Docket No. 50-412  
Serial No. BV-92-043

SUBJECT: OPERABILITY OF THE ALTERNATE MINIMUM FLOW PATHS FOR THE HIGH-HEAD  
SAFETY INJECTION PUMPS (TAC NO. M84935)

NRC INFORMATION NOTICE 92-61, SUPPLEMENT 1: LOSS OF HIGH HEAD  
SAFETY INJECTION

FIGURE 1  
EXISTING SHEARON HARRIS HIGH HEAD INJECTION SYSTEM

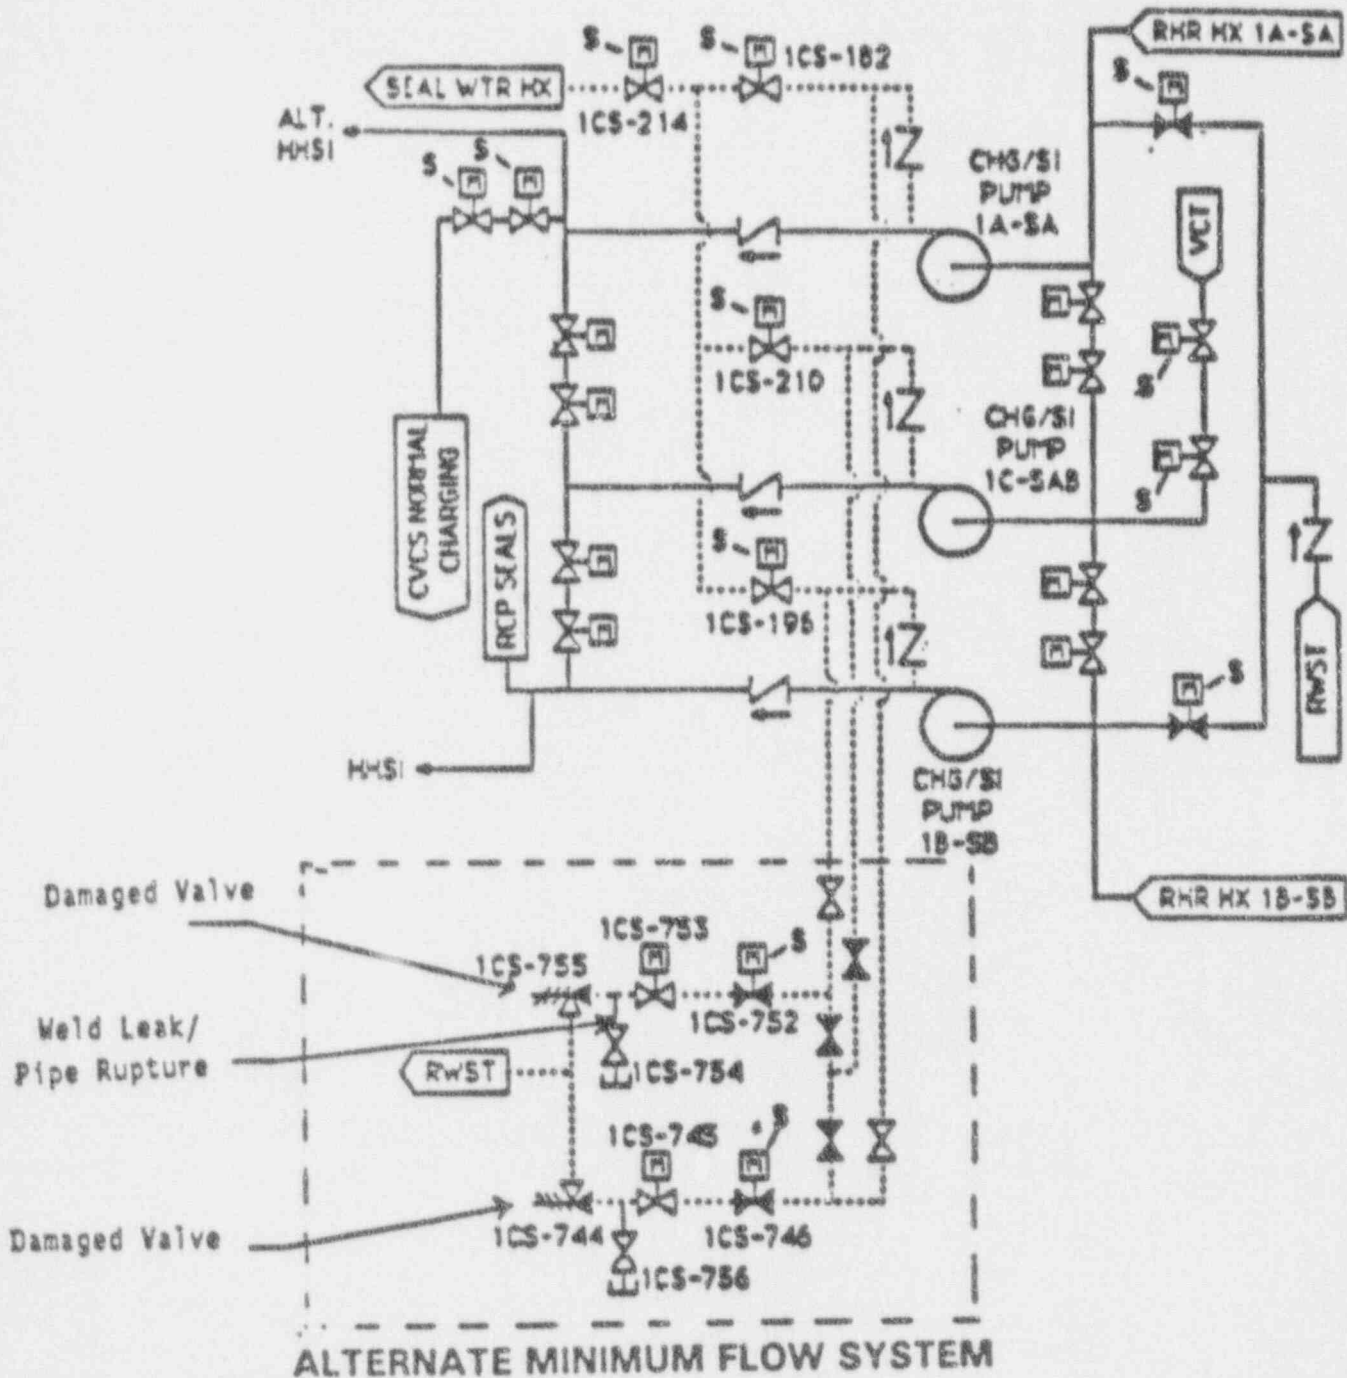
On April 3, 1991, Carolina Power & Light Company (the licensee) determined that the HHSI system for the Shearon Harris Nuclear Power Plant had been in a degraded condition during the previous operating cycle. The degraded condition resulted from relief valve and drain line failures in the AMF system for the charging/safety injection pumps (CSIPs) which would have diverted a significant amount of safety injection (SI) flow away from the reactor coolant system (RCS). Additional description of the existing AMF system and additional discussion regarding the specifics of this event are contained in Information Notice 92-61, "Loss of High Head Safety Injection," dated August 20, 1992, and in NRC Special Inspection Report 50-400/92-201, dated September 1, 1992. In addition, Figure 1 provides a schematic of the existing HHSI system at Shearon Harris.

On September 17, 1992, the licensee tested the HHSI AMF system. When the 1CS-746 motor-operated isolation valve was opened to test train "A" of the HHSI AMF system (1CS-746 will stroke fully open in approximately 7 seconds), relief valve 1CS-744 chattered slightly for several seconds and then

successfully opened. When the ICS-752 motor-operated isolation valve was opened (also requiring approximately 7 seconds) to test train "B" of the HHSI AMF system, relief valve ICS-755 chattered significantly, the valve bellows failed, and the test was halted. Additional discussion regarding these tests is contained in NRC Inspection Report 50-400/92-17, dated October 1, 1992.

The licensee has indicated that the chattering of the ICS-755 relief valve is believed to have been caused by hydraulic effects associated with opening the ICS-752 motor-operated isolation valve. The NRC staff believes that the fluid frictional and dynamic pressure loss characteristics of the long inlet piping upstream of ICS-752 may have also contributed to the chattering. The licensee indicated that the testing, disassembly, and examination of the ICS-755 relief valve identified that the valve lift setpoint (2300 psi) had not changed, and that the bellows failure was caused by cyclic fatigue of an inside weld. Static testing to verify the valve lift setpoint had been routinely performed, during the plant lifetime, whereas testing to simulate flow through the valve to assure proper operation and reseating apparently never was performed.

The Crosby relief valve technical manual states that chattering can affect the life, operation, and performance of a relief valve. The manual recommends that relief valves not have restricted inlets because restricted inlets can cause valve chatter. The opening and closing of the motor-operated isolation valve in the existing HHSI AMF design at Shearon Harris restricts the inlet to the relief valve. In addition, relief valves are generally designed to provide system overpressure protection and are not designed for continuous fluid throttling purposes.

FIGURE 2  
MODIFIED SHEARON HARRIS HIGH HEAD INJECTION SYSTEM

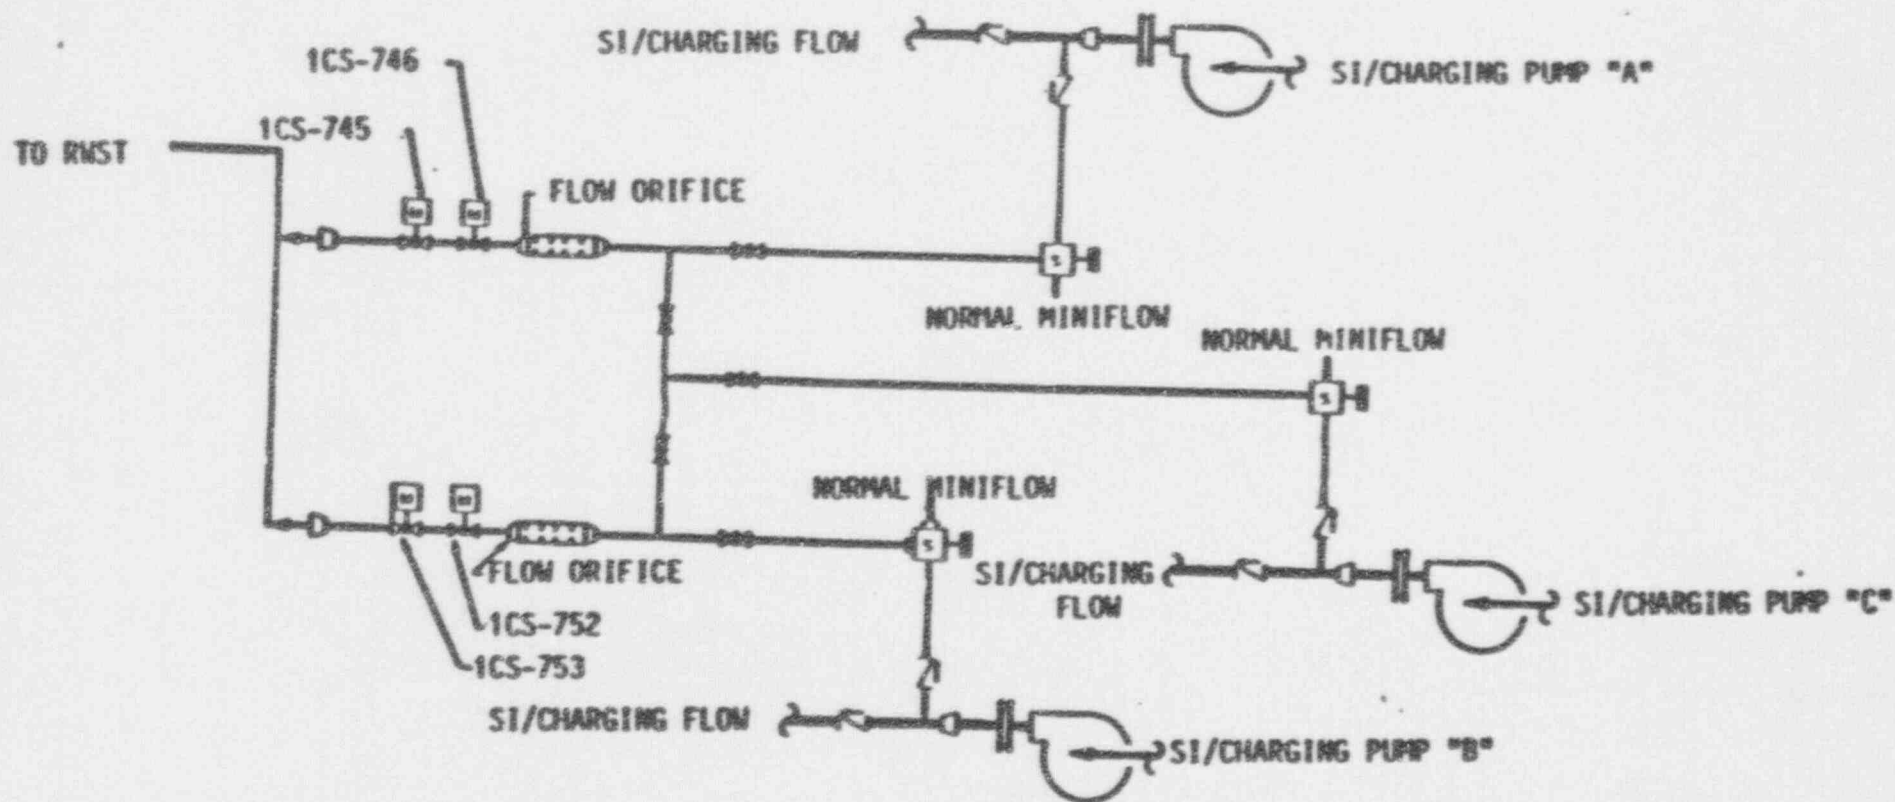
The licensee also indicated that modifications will be made to the HHSI AMF system before restarting the plant from the current refueling outage. Figure 2 provides a schematic of the proposed modifications to the HHSI AMF system at Shearon Harris. The licensee intends to install flow restricting orifices upstream of the motor-operated isolation valves and to remove the relief valves. The motor-operated isolation valve actuation logic will also be modified so that the isolation valves will open when a safety injection signal is present coincident with RCS pressure above approximately 2300 psi.
